Point Beach Nuclear Plant, Units 1 and 2
Dockets 50-266 and 50-301

Subject: Response to Request for Additional Information Regarding License Amendment Request 287, Application to Adopt 10 CFR 50.69, "Risk informed Categorization and Treatment of Structures, System, and Components (SSCs) for Nuclear Power Plants"

Response to Request for Additional Information

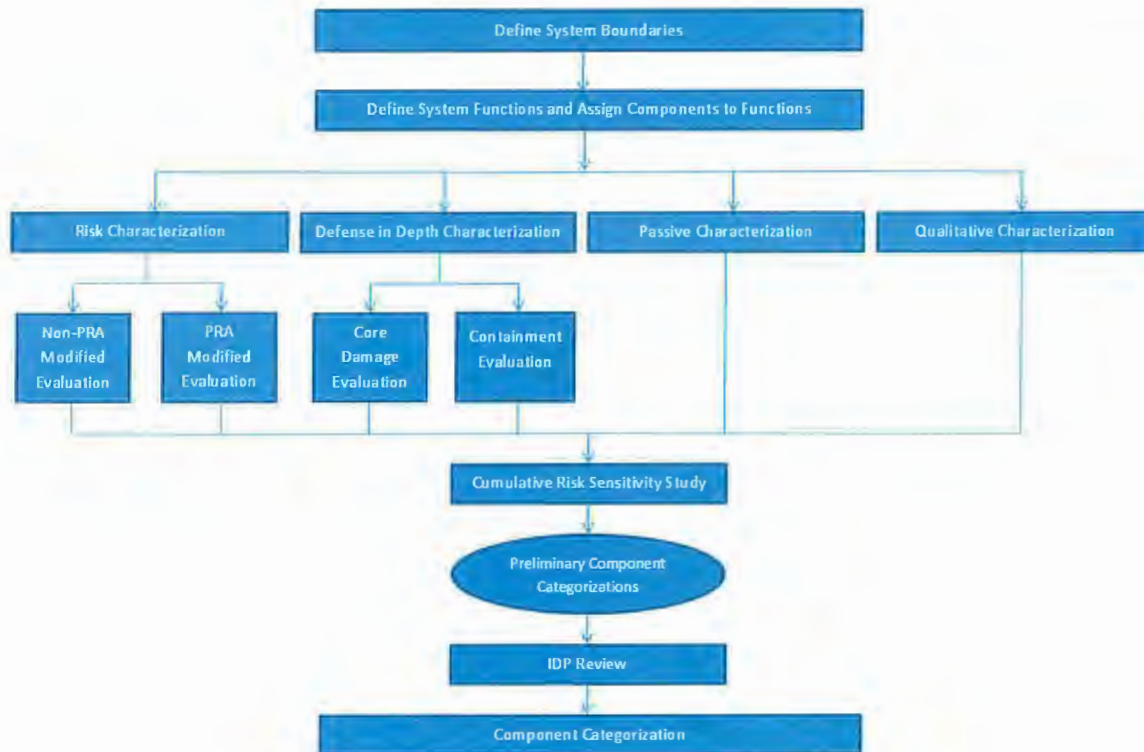
- a. Summarize, in the order they will be performed, the sequence of elements or steps that will be followed to categorize a respective system. A flow chart, such as that provided in the NEI presentation (ADAMS Accession Number ML17249A072) for the September 6, 2017, public meeting with NEI regarding 10 CFR 50.69 LARs (ADAMS Accession Number ML17265A020) may be provided instead of a description. The steps should include:
 - i. The input from all PRA evaluations such as use of the results from the internal events, internal flooding, seismic, and fire PRAs;
 - ii. The input from non-PRA approaches (other external events, and shutdown);
 - iii. The input from the responses to the seven qualitative questions in NEI 00-04, Section 9.2;
 - iv. The input from the defense-in-depth (DID) matrix;
 - v. The input from the passive categorization methodology.

a-c. The process to categorize each system will be consistent with the guidance in NEI 00-04, “10 CFR 50.69 SSC Categorization Guideline,” as endorsed by RG 1.201. RG 1.201 states that “the implementation of all processes described in NEI 00-04 (i.e., Sections 2 through 12) is integral to providing reasonable confidence” and that “all aspects of NEI 00-04 must be followed to achieve reasonable confidence in the evaluations required by §50.69(c)(1)(iv).” However, neither RG 1.201 nor NEI 00-04 prescribe a particular sequence or order for each of the elements to be completed. Therefore, the order in which each of the elements of the categorization process (listed below) is completed is flexible and as long as they are all completed; they may even be performed in parallel. Note that NEI 00-04 only requires Item 3 to be completed for components/functions categorized as LSS by all other elements. Similarly, NEI 00-04 only requires Item 4 to be completed for safety related active components/functions categorized as LSS by all other elements.

On the following page is an example of the major steps of the categorization process described in NEI 00-04.
